Bosworth St: Existing STR

Bosworth St: Proposed STR

Proposed Changes

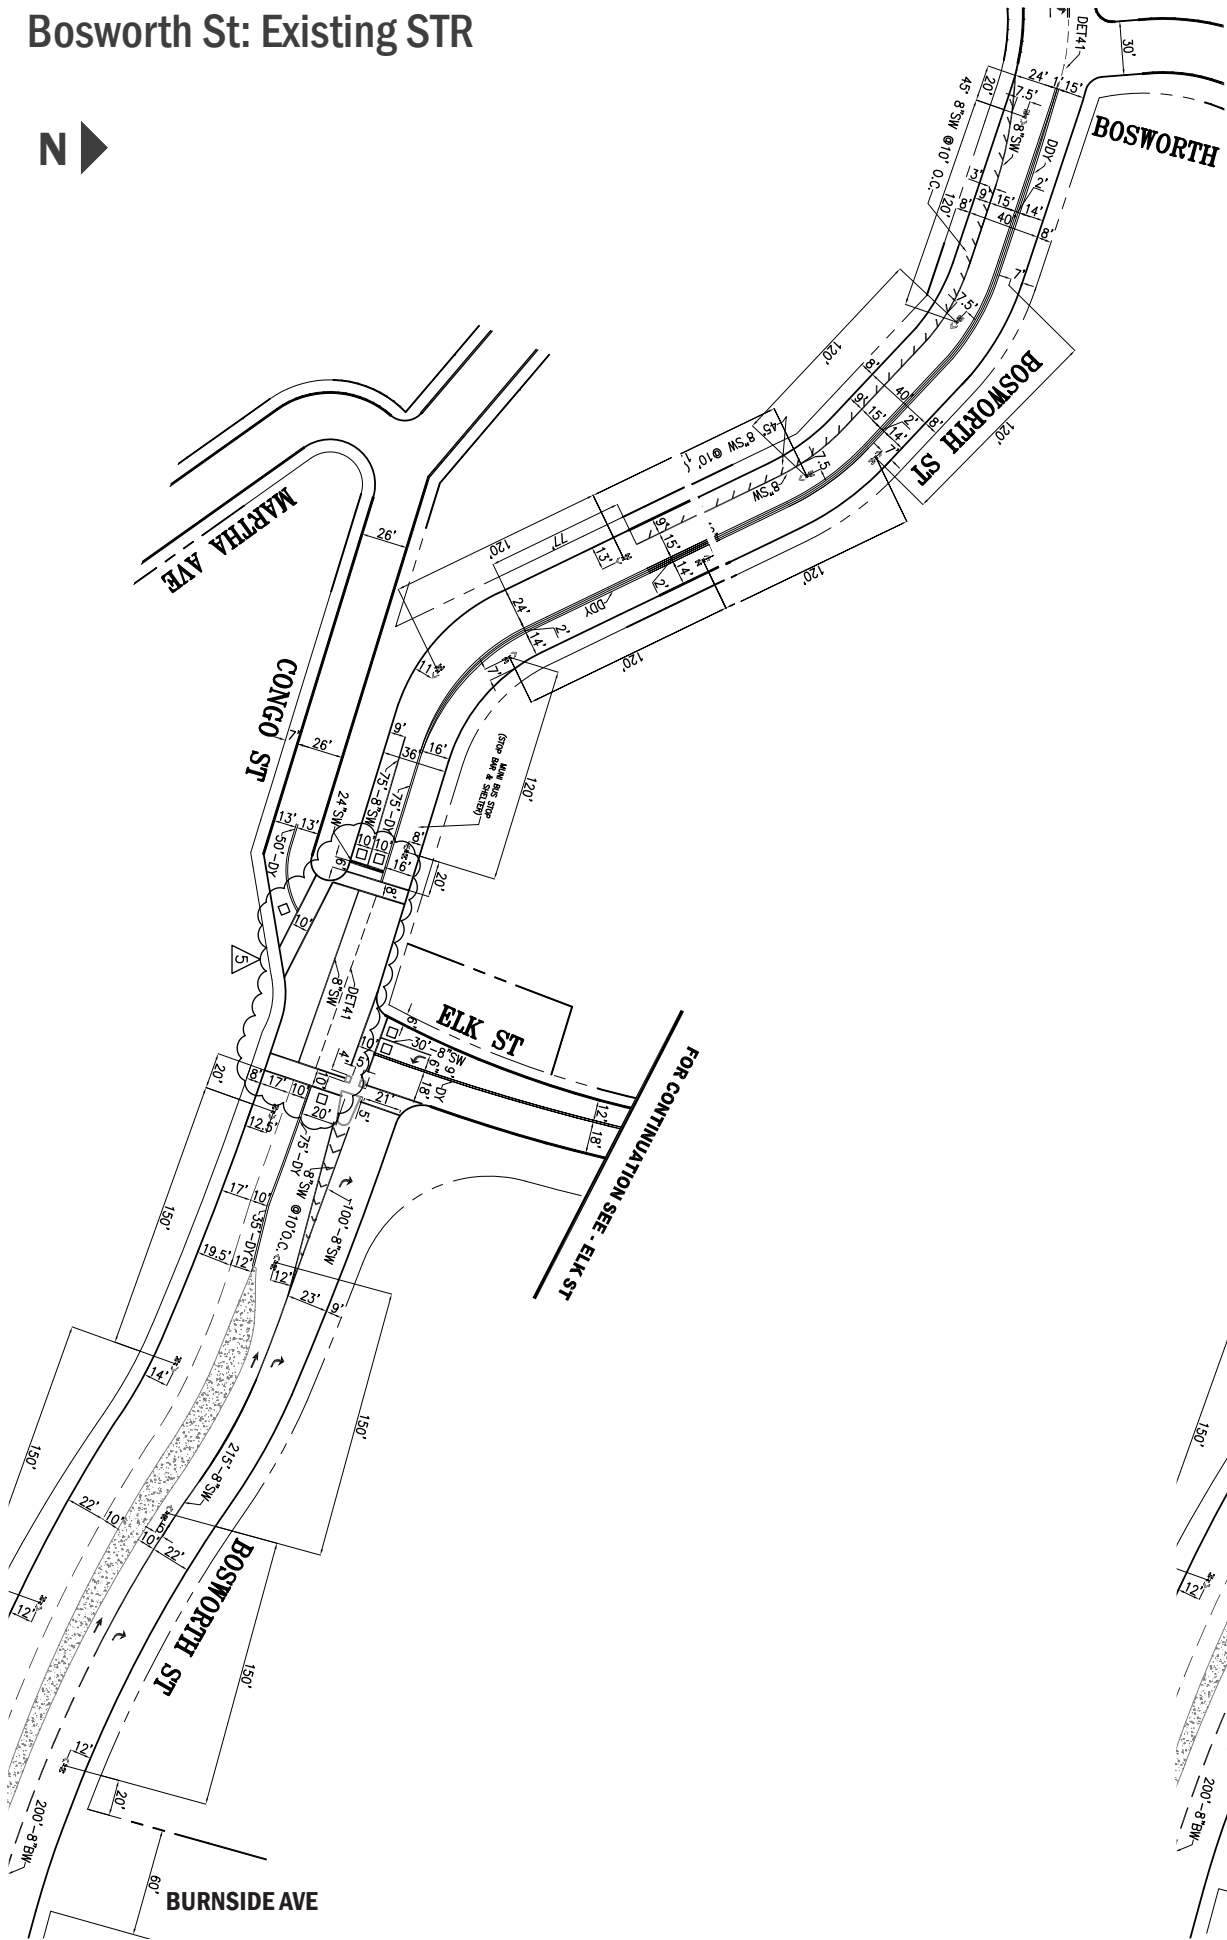
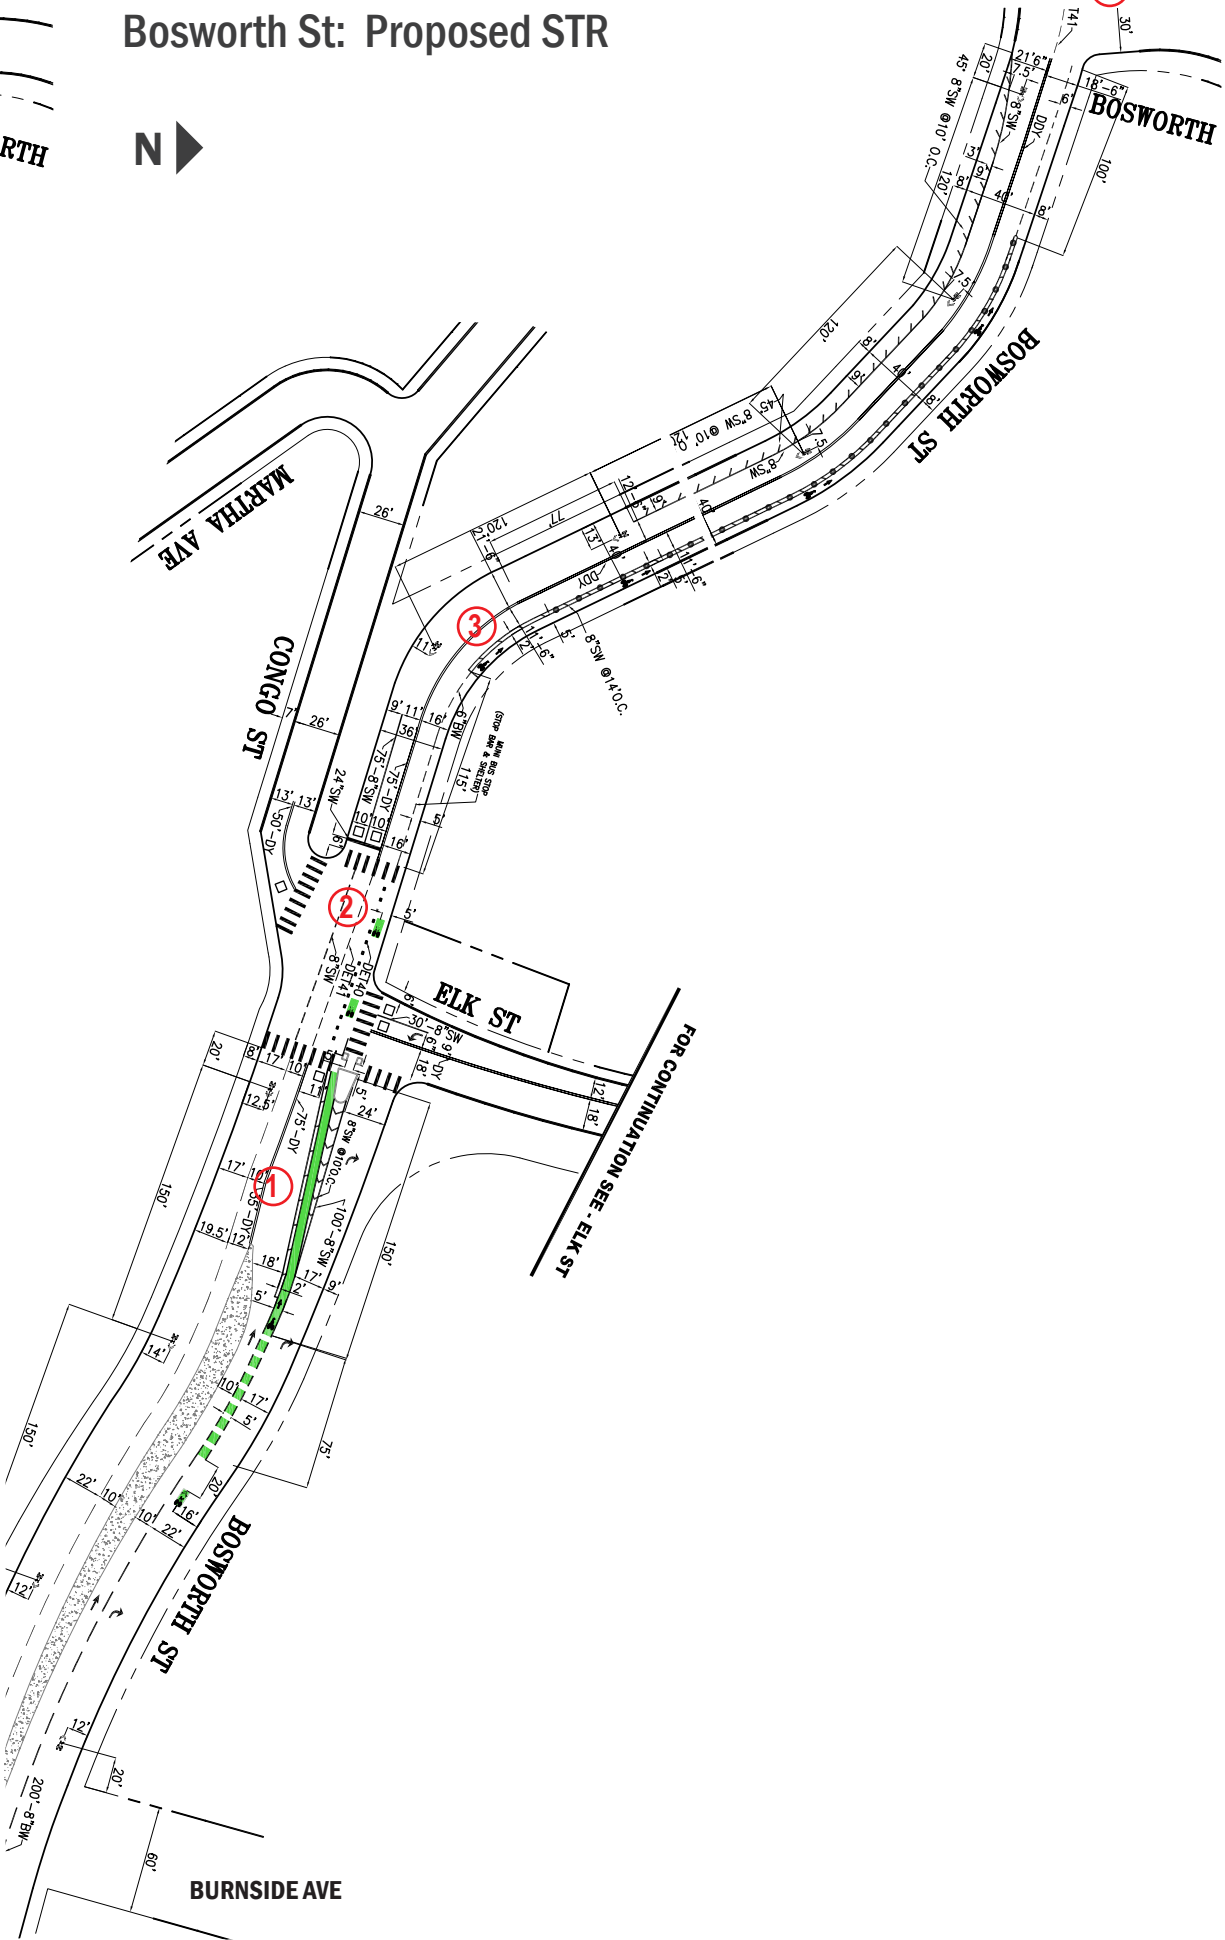
- 1. Add bike lane from Bosworth St. and Elk St. to 225' easterly
- 2. Add intersection markings including continental crosswalks and greenback sharrows at Bosworth St. and Elk St.
- 3. Adjust center-line on Bosworth St. from Elk St. to the O'Shaughnessy Path and add 5' curbside bike lane with 2' buffer.
- 4. Add sign at beginning of O'Shaughnessy Path at Bosworth to indicate start of shared bike/pedestrian pathway.
